**Proposed Wellsite
Sutton's Lane, Great Altcar
Supplementary Transport Statement**

November 2019

PLANNING APPLICATION LCC/2019/0037 – PROPOSED HYDROCARBON EXPLORATION SITE AT SUTTONS LANE, GREAT ALTCAR, FORMBY

Appendix 3 – Road Width Measurements

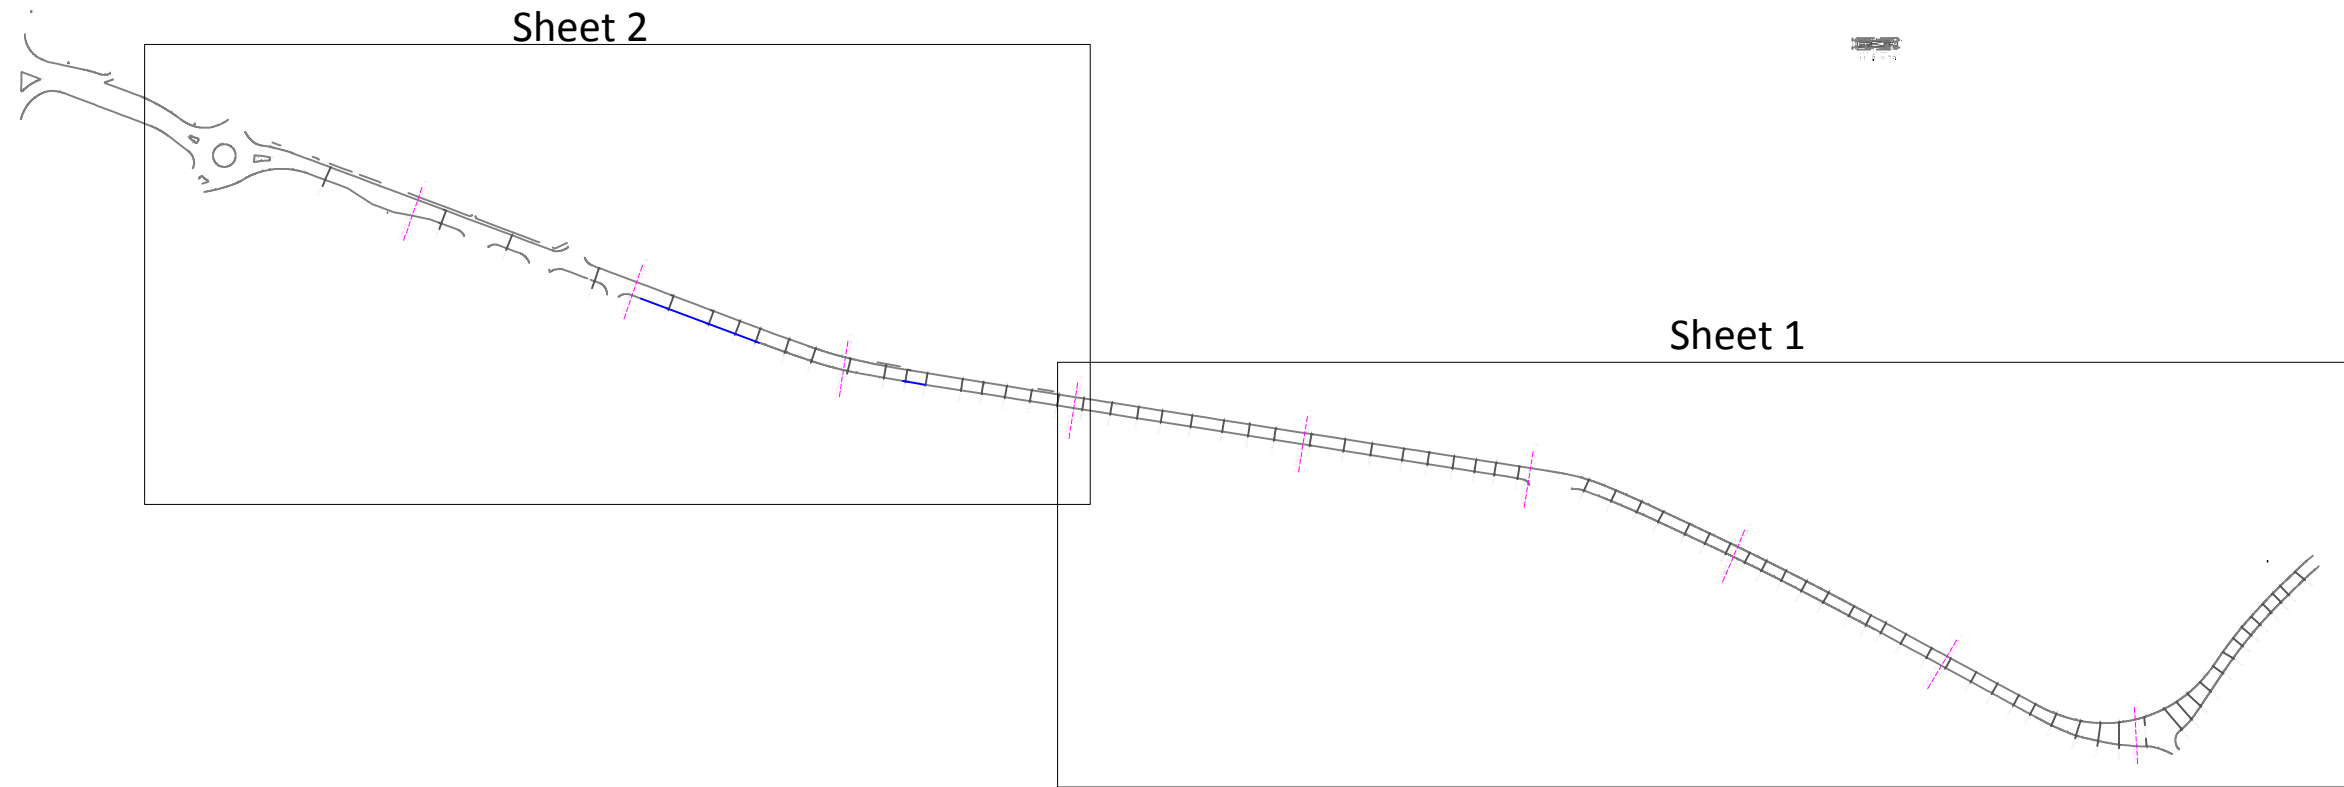
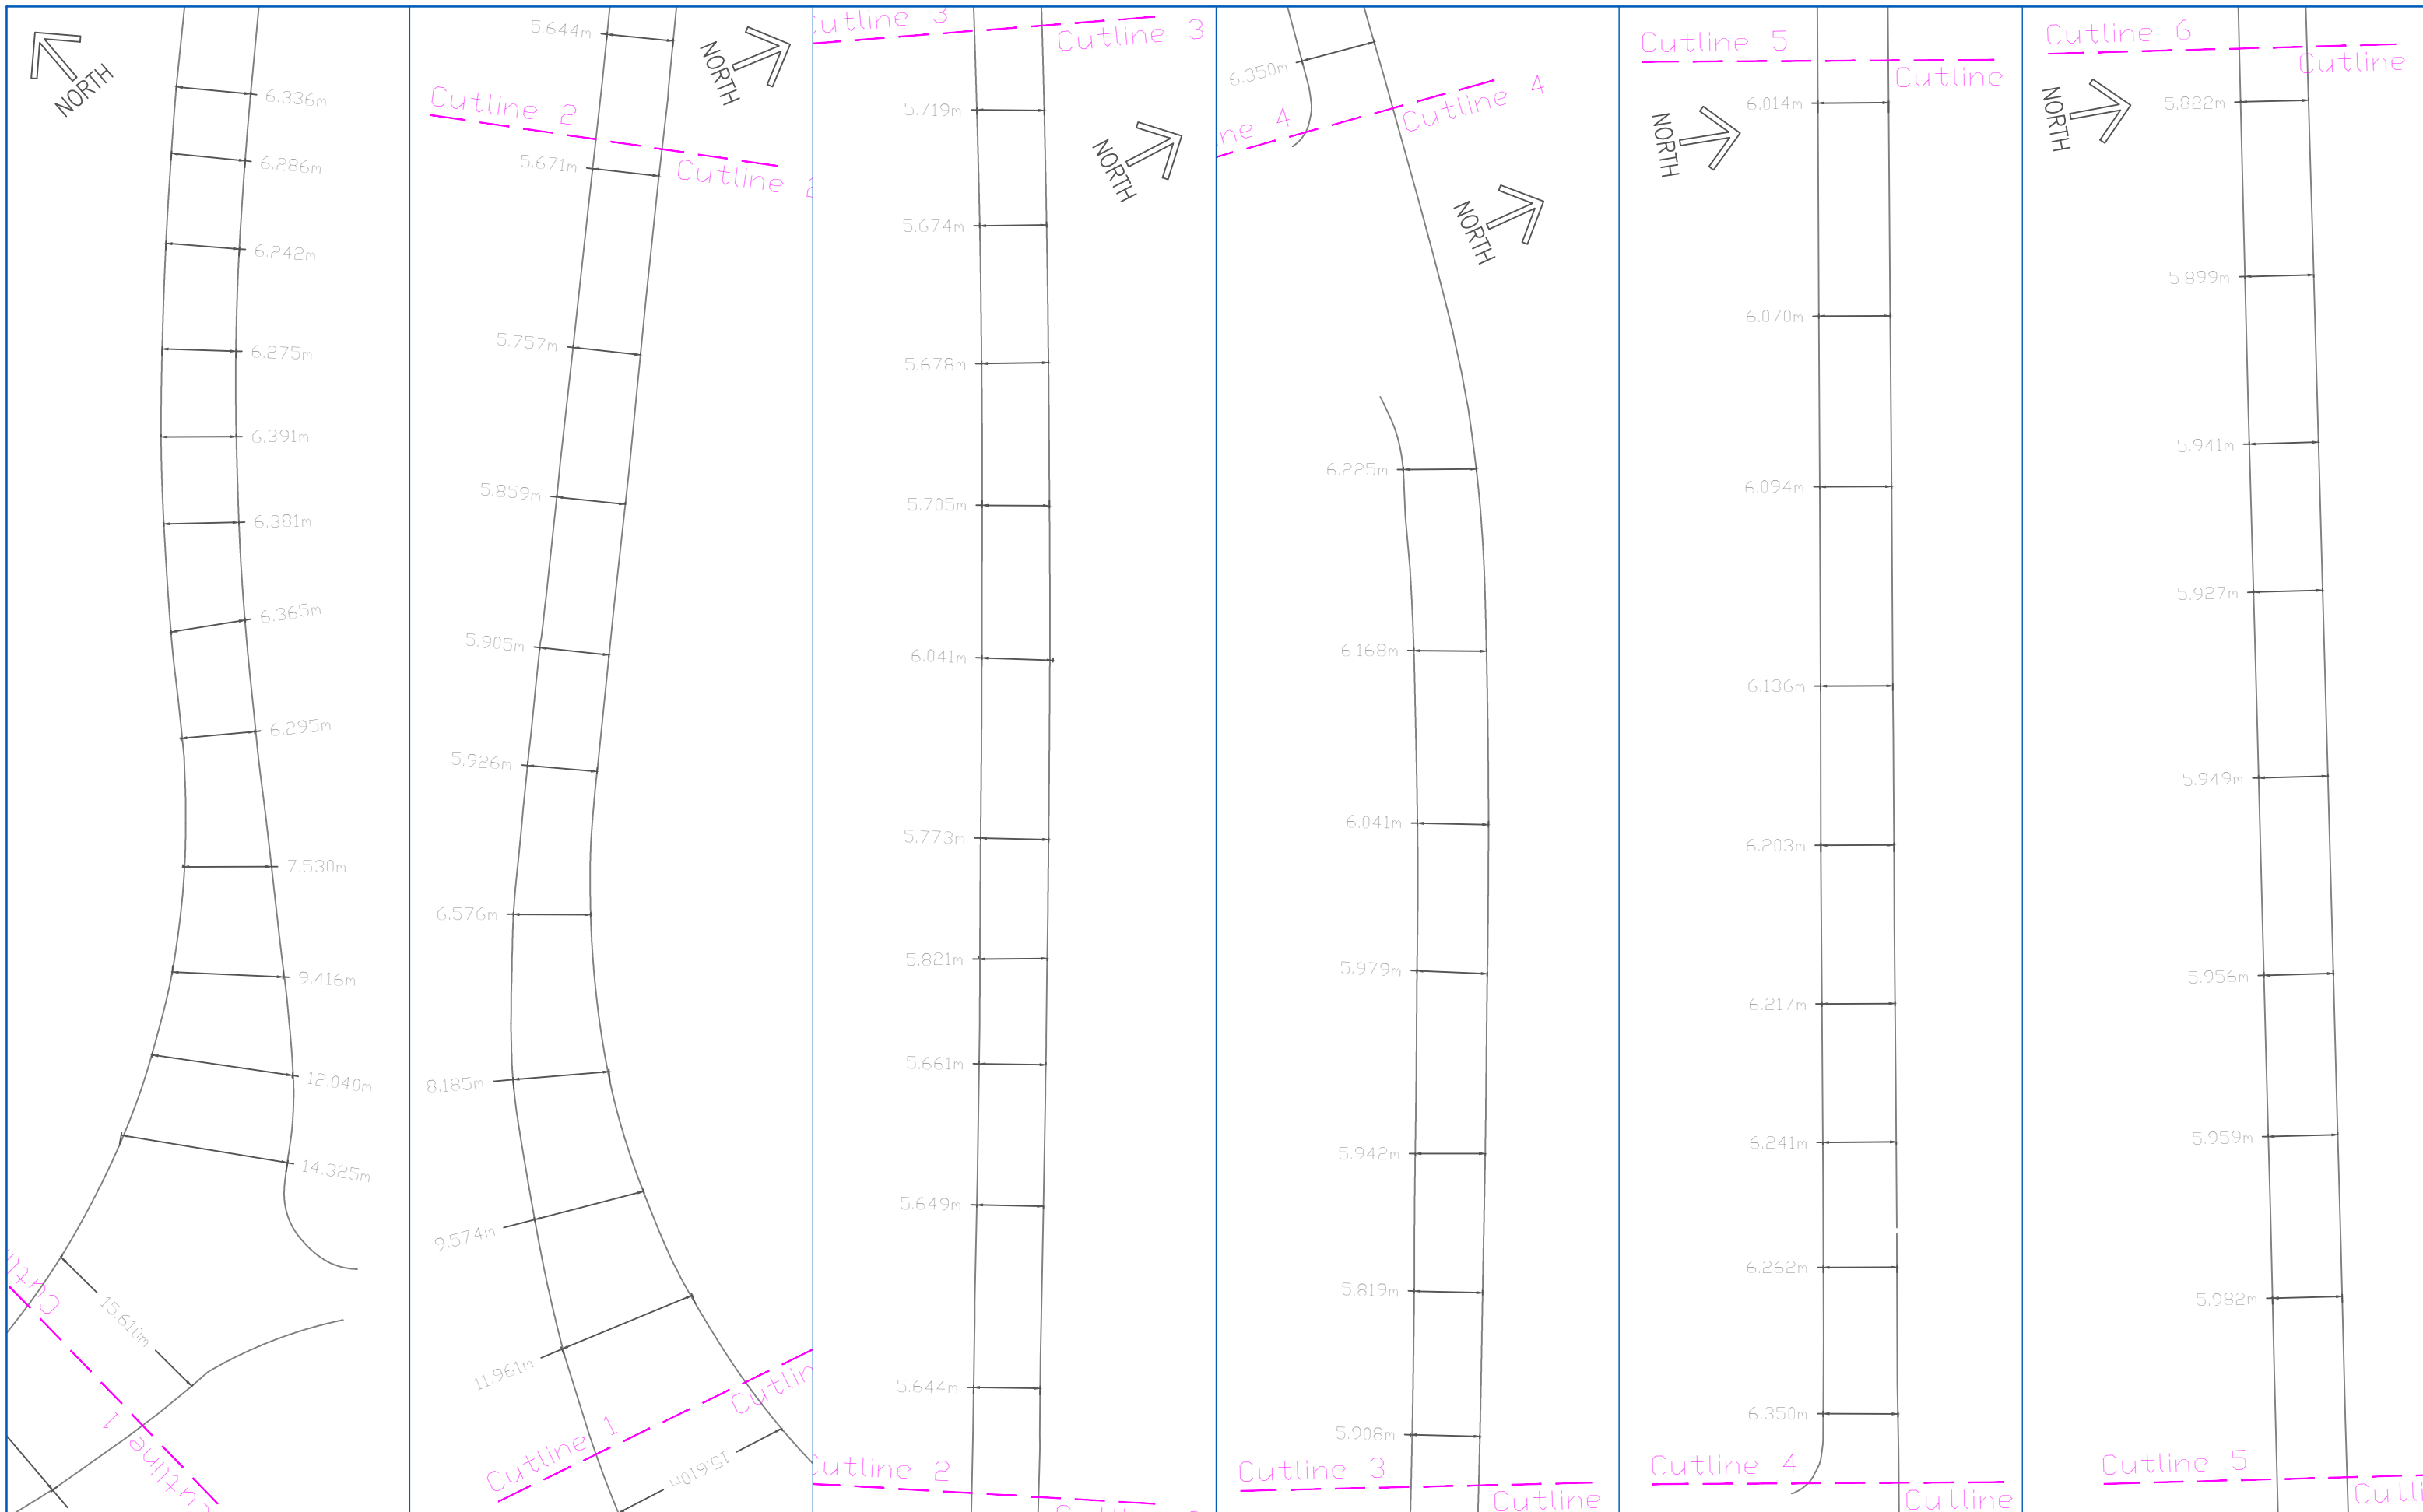
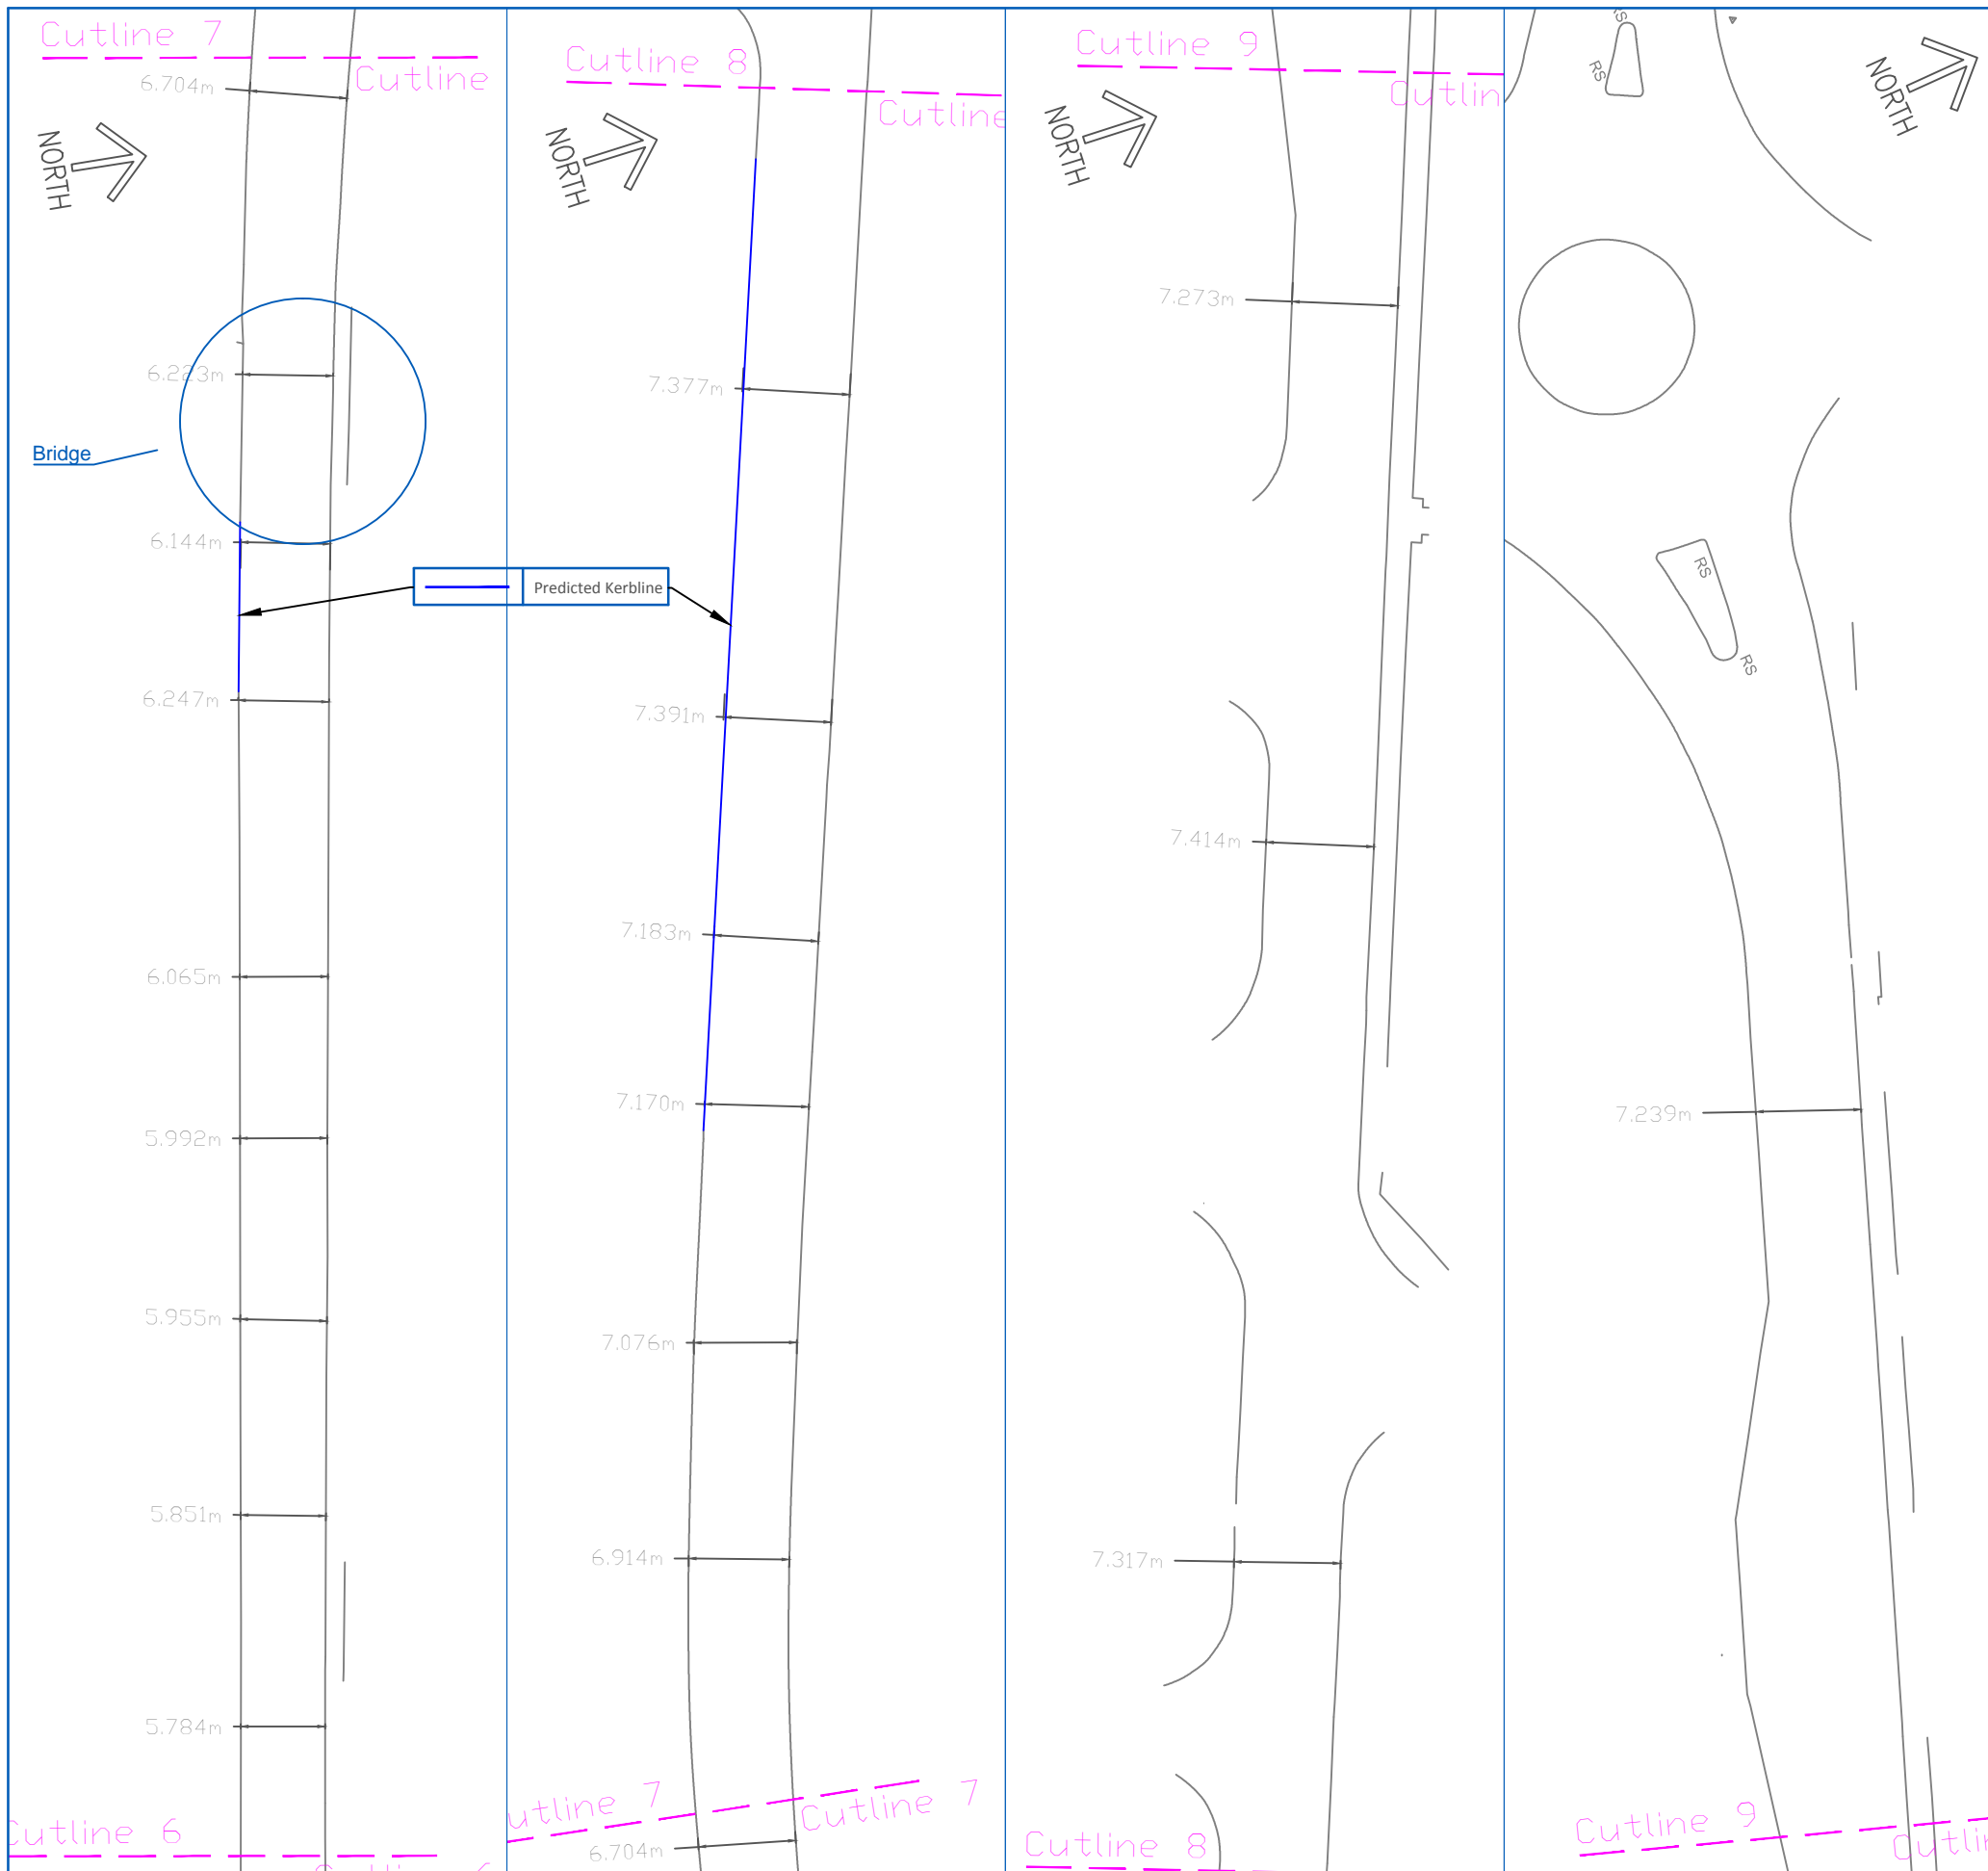
- 5.1.1 **Regulation 25 Request (Appendix 1) – LCC Highways:** *“LCC Highways have raised an issue with the carriageway widths on Lord Sefton Way and state that roads narrower than 5.5 metres are not well suited to accommodating 2 way HGV movements and particularly increases in numbers of such vehicles which would be the impact of the proposal. There is limited information within the ES to demonstrate that the existing carriageway is suitable to accommodate such movements or if any localised widening or other improvement would be required. The only section of highway beyond Suttons Lane that appears to have been assessed in terms of large HGVs appears to be the Altcar Lane/Stephenson Way roundabout in Sefton. None of the other potential pinch points or substandard sections of highway in Lancashire appear to have been assessed. You will note that Highways have asked for passing places to be identified and suitably marked using signage. Highways have stated that these works and the other improvement works that may be required to the public highway would need to be the subject of a section 278 agreement.”*

- 5.1.2 As detailed in the TS, the carriageway width on the site access route was measured to generally be comfortably above the 5.5m minimum width referenced by LCC Highways. The route includes sections of Lord Sefton Way and Altcar Road, which are both two-way single carriageways with a centreline marking throughout and no existing signing to indicate that there was any road narrowing. As noted in the Traffic Signs Manual (DfT, 2019), “[w]here the carriageway is less than 5.5m in width, the centre line should be omitted”. It is also noted that the route is already utilised by HGVs travelling in both directions, with no reported issues or collisions associated with these movements.

- 5.1.3 However, in order to provide further evidence, a topographical survey of the full route between the A565 and the Sutton's Lane junction with Lord Sefton Way has been undertaken. The drawing attached as Appendix 3 shows the different carriageway widths on the route. This on-site survey data shows that the roads along the route measure in excess of 5.5m at each point. This is consistent with pre-application advice provided by LCC Highways (Ref: Neil Stephens) at a meeting that Lord Sefton Way should be wide enough to allow the passing of HGVs.

- 5.1.4 There is a section of carriageway that is narrower than the typical widths, and it is located immediately west of the bend in Lord Sefton Way that is approximately 150m south of the Sutton's Lane junction. The narrowest point along this section measures 5.644m, which is still in excess of the required 5.5m even at this point.
